Subregional RTEP Committee – Western FirstEnergy Supplemental Projects

January 16, 2026

Changes to the Existing Projects

s3495.1: Originally presented in 2/18/2022 and 6/14/2024 SRRETP Western meetings.

ATSI Transmission Zone M-3 Process Cascade (Cedar Street) 69 kV Line

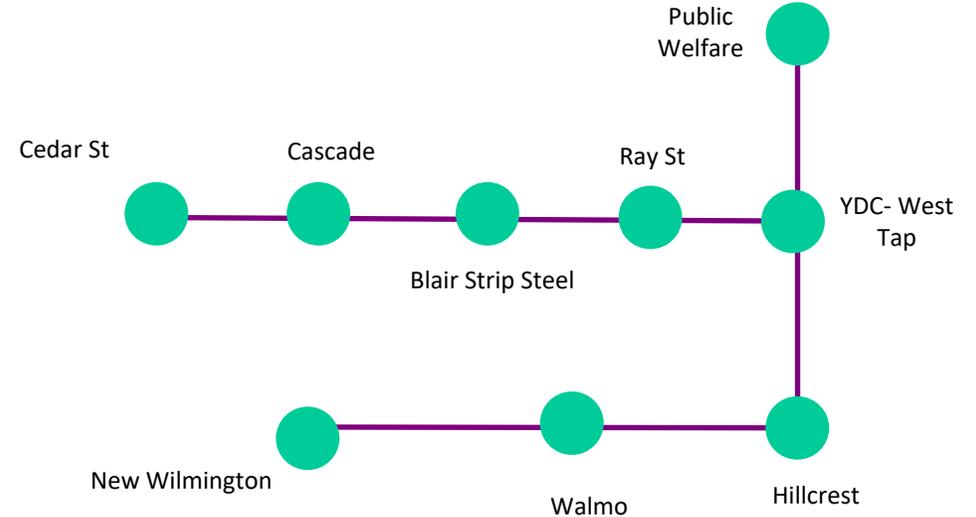
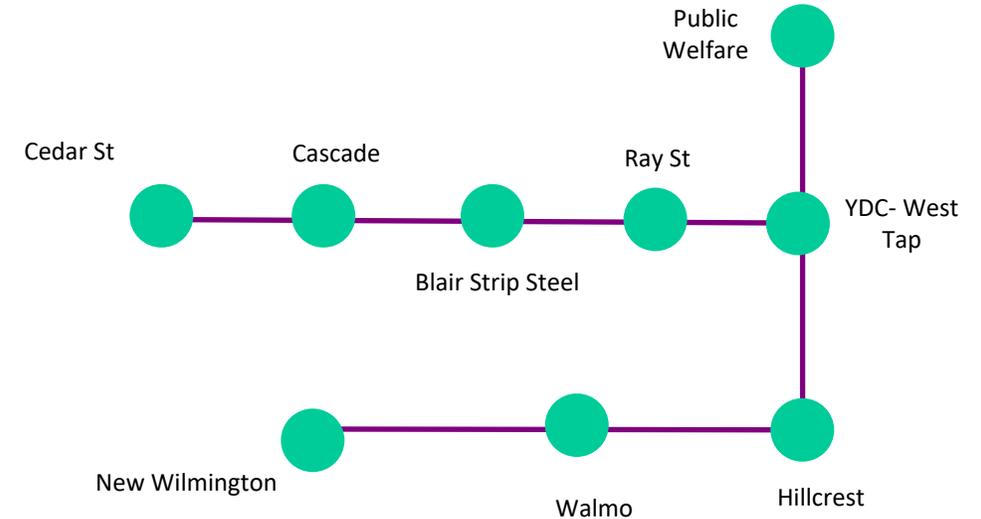
- Reconductor the Cascade (Cedar Street) 69 kV Line with **556 ACSR 26/7 conductor** ~~336 ACSR 36/7 conductor~~, approximately 18.3 miles.

~~After Proposed Solution: 80 MVA SN / 96 MVA SE / 90 MVA WN / 114 MVA WE~~

~~After Proposed Solution: 80 MVA SN / 96 MVA SE / 90 MVA WN / 114 MVA WE~~

~~After Proposed Solution: 80 MVA SN / 96 MVA SE / 90 MVA WN / 114 MVA WE~~

~~After Proposed Solution: 80 MVA SN / 96 MVA SE / 90 MVA WN / 114 MVA WE~~

~~After Proposed Solution: 80 MVA SN / 96 MVA SE / 90 MVA WN / 114 MVA WE~~

- After Proposed Solution: **111 MVA SN / 134 MVA SE / 125 MVA WN / 159 MVA WE**

- After Proposed Solution: **111 MVA SN / 134 MVA SE / 125 MVA WN / 159 MVA WE**

- After Proposed Solution: **111 MVA SN / 134 MVA SE / 125 MVA WN / 159 MVA WE**

- After Proposed Solution: **111 MVA SN / 134 MVA SE / 125 MVA WN / 159 MVA WE**

- After Proposed Solution: **111 MVA SN / 134 MVA SE / 125 MVA WN / 159 MVA WE**
